**URGENT MEDICAL DEVICE CORRECTION****September 10, 2019****To:** Hospital/Surgeon Name**Affected Product:** ROSA Brain 3.0**Serial No.:** BRxxxxx

**Affected Product: ROSA Brain 3.0      Field Action Reference: ZFA2019-00253**

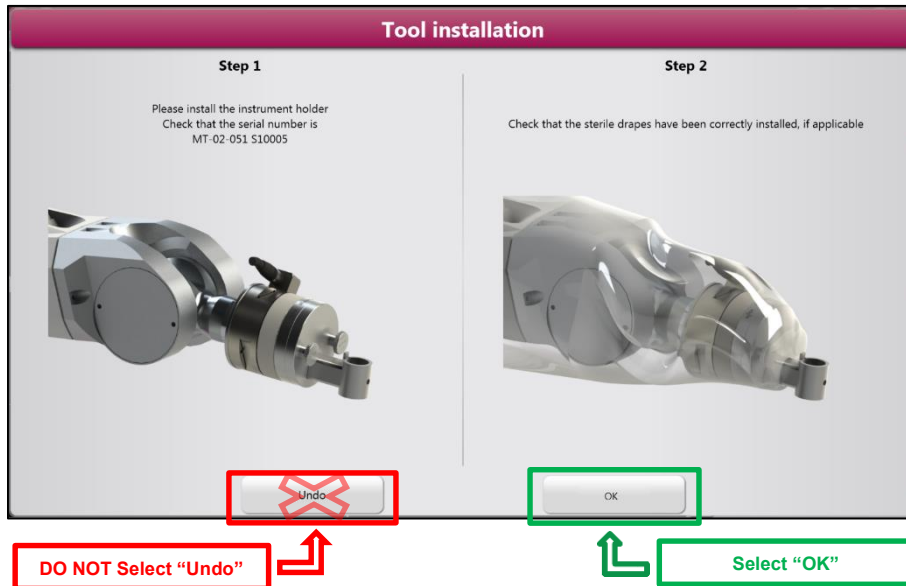
After the registration of the patient within the ROSA Brain 3.0 device, the issue may occur only in the guidance mode (e.g. when the robot arm is on trajectory), when the user selects the optical distance sensor and sends the robot arm on each entry point, and then selects the instrument holder. In such case, the use of the "Undo" button in the Tool installation panel will result in the issue due to a software anomaly.

## Actions Required By Users (Workaround):

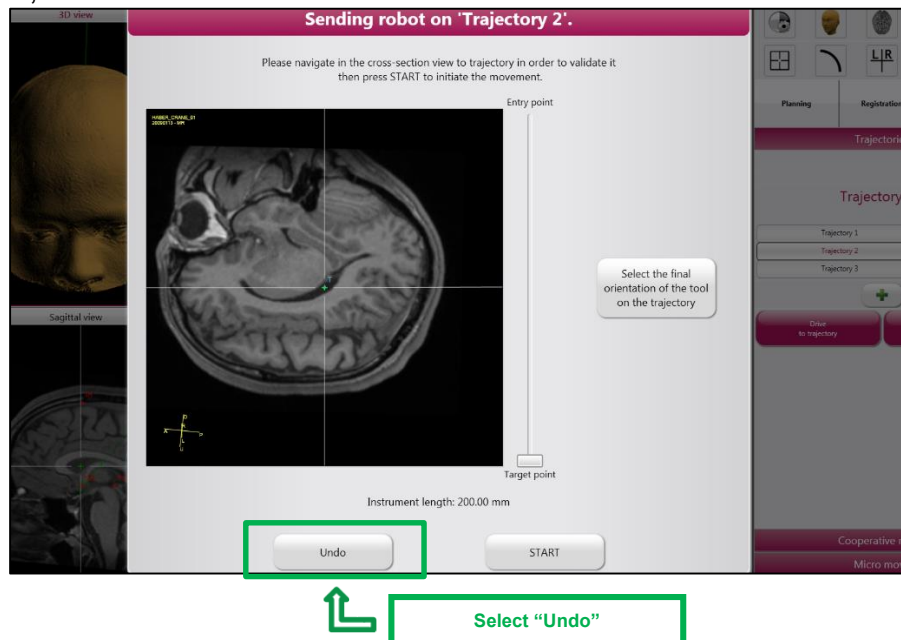
- Once you select the instrument holder, if you would like to Undo your action :
  - DO NOT select "Undo"
  - Select "OK"

- In the next frame, select Undo

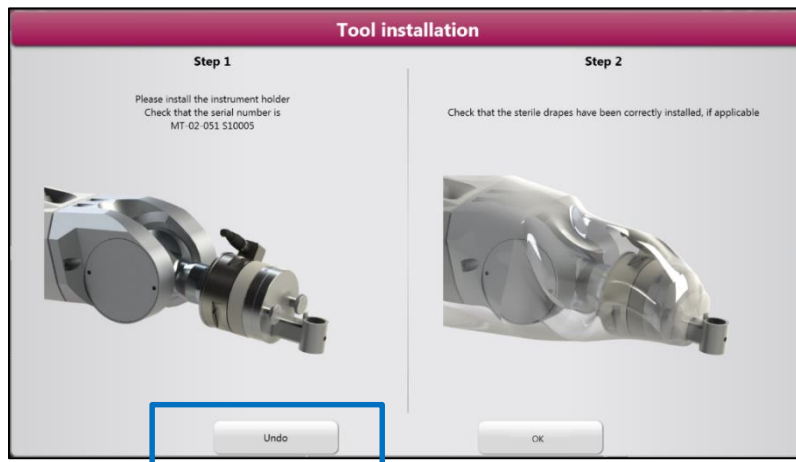
1. Use of the optical distance sensor during guidance mode, e.g. to mark entry points on the patient's head with a skin marker
2. Choosing drive to a trajectory and selection of the instrument holder

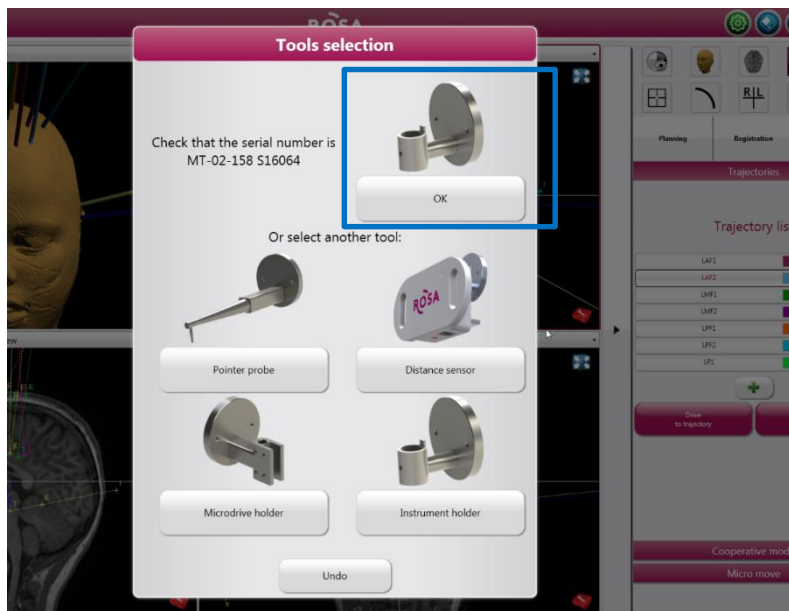
3. Installation of the instrument holder on the robot arm
4. Clicking undo on the tool installation frame
